SERVICE BULLETIN AMATEUR RADIO

SUBJECT	DATE
TH-75A INTERMITTENT MEMORY LOSS	08/08/90

FIGURE 4

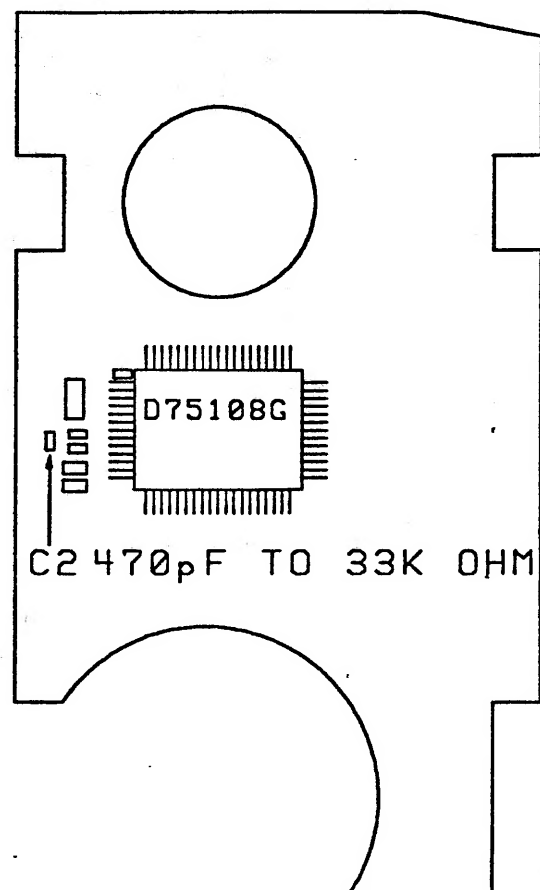
7. Lay the Control board on a soft cloth to avoid scratching the LCD.
8. Locate chip capacitor C2 on the Control board. **Figure 4**
9. Replace C2 with a 33K ohm chip resistor.

FIGURE 5

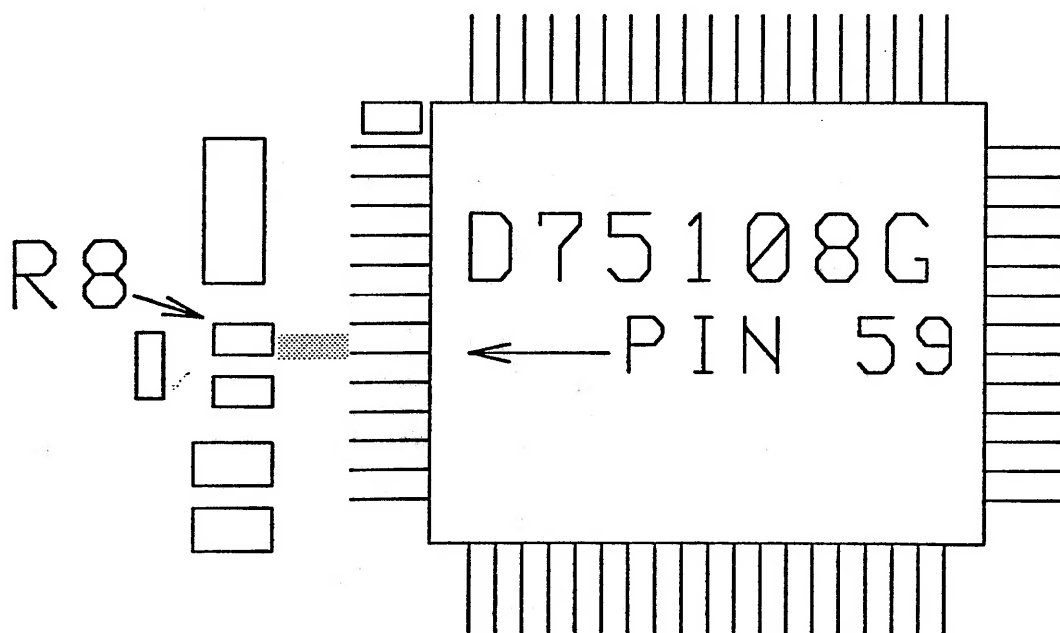
10. Remove the protective coating from the foil between pin 58 of the microprocessor and chip resistor R8. Presolder the exposed foil. **Figure 5**
11. Size, cut, and bend the leads of the 470pF ceramic disc capacitor and then install the component between pin 59 of the microprocessor and the ground side of the 33K ohm chip resistor. **Figure 6**

FIGURE 7

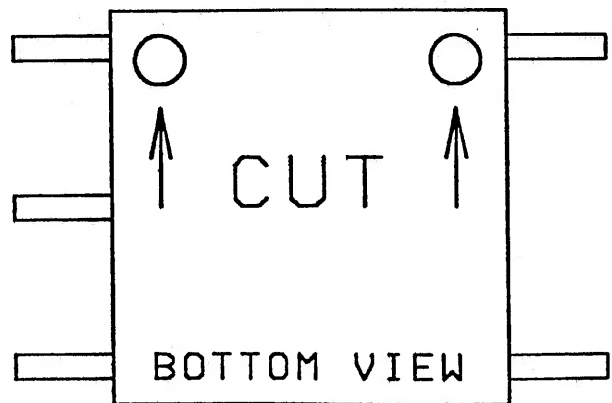
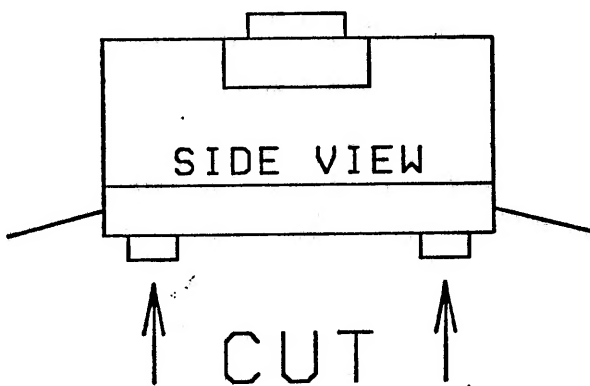
12. Remove the screw from the PTT switch assembly and then remove the rubber PTT cover from the board. Be careful not to lose the black plastic plate that fits inside the rubber cover.
13. Remove the PTT switch from the board.
14. Cut the tabs off the bottom of the new PTT switch to allow the switch to lay flush on the board. Figure 7
15. Install the PTT switch.
16. Assemble the transceiver.
